CITY OF MONROE

GATEWAY SIGNAGE DESIGN REVISIONS 1

02/17/2020

Concept 7E - Without Landscaping

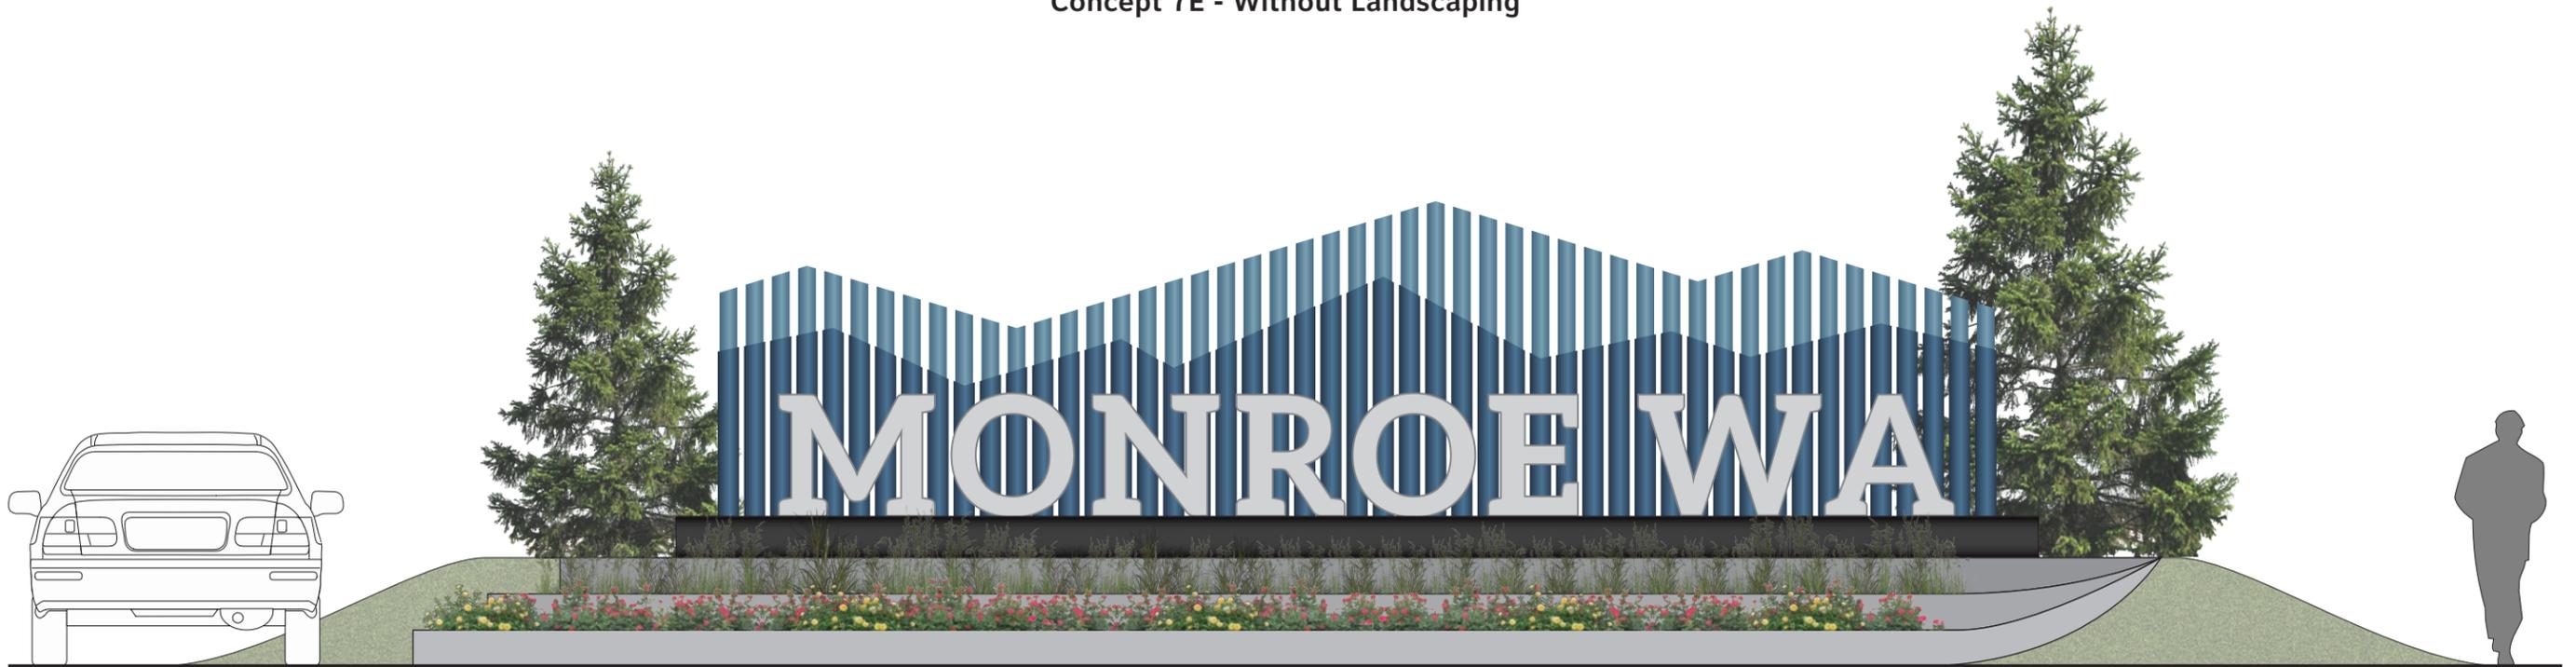
- Changed the material of the "MONROE" type to brushed metal.
- Modified the color scheme of the "Mountains" to be less monochrome. The new colors are intended to create the depth of the Cascade Mountains.
- Added the acronym "WA".
- Added an i-beam element to the base to utilize a material and form that would create a connection to the city's railroad history.

Concept 7F

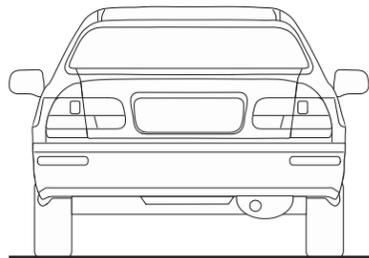
- Changed the material of the "MONROE" type to brushed metal.
- Modified the color scheme of the "Mountains" to be less monochrome. The color scheme imitates the Cascade Mountains at dusk. The blue and purple colors are also similar to Monroe's logo colors.
- Added the word "Washington".
- Added an i-beam element to the base to utilize a material and form that would create a connection to the city's railroad history.

Concept 7G

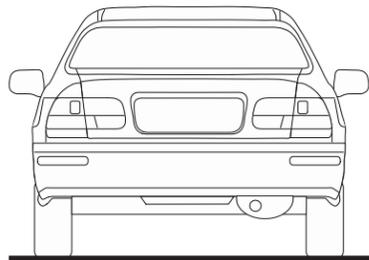
- Changed the material of the "MONROE" type to brushed metal.
- Modified the color scheme of the "Mountains" to be less monochrome. The new colors are intended to create the depth of the Cascade Mountains.
- Added the word "Washington".
- Added an i-beam element to the base to utilize a material and form that would create a connection to the city's railroad history. An architectural perforated metal panel is added to the front of the i-beam to represent the Skykomish River and resemble the flow of water.

Concept 7J - Without Landscaping

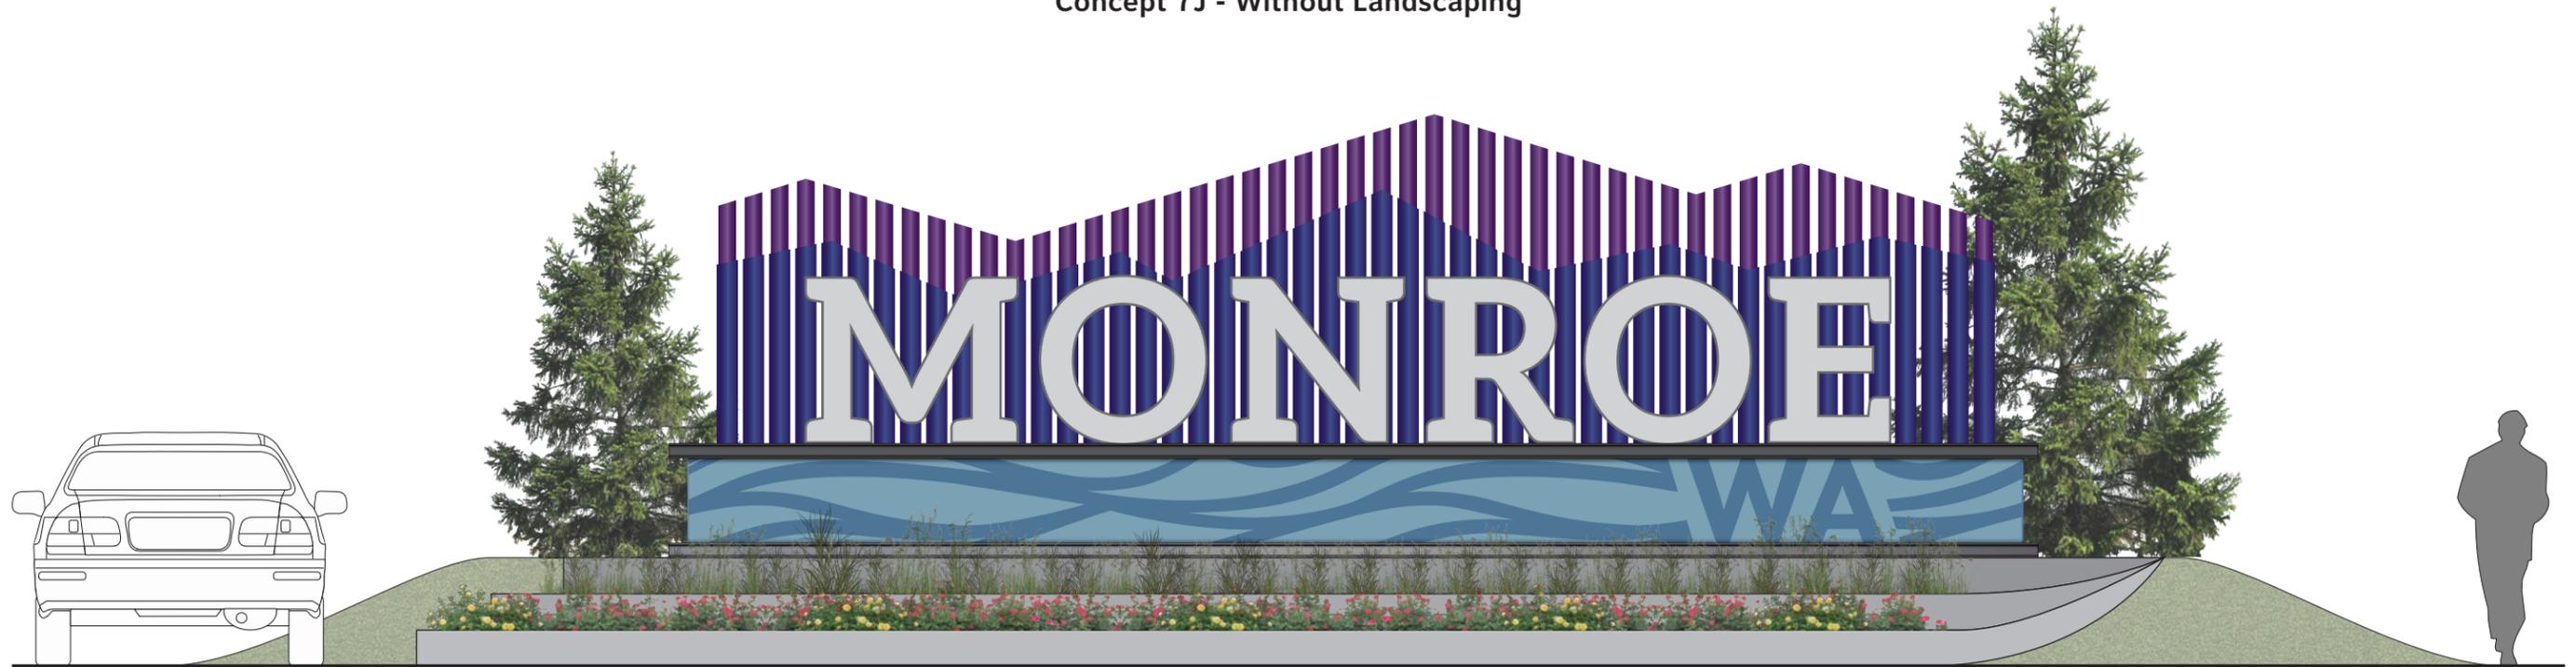
- The design of this option is the same as Concept 7I. The only difference is the color scheme of the base.
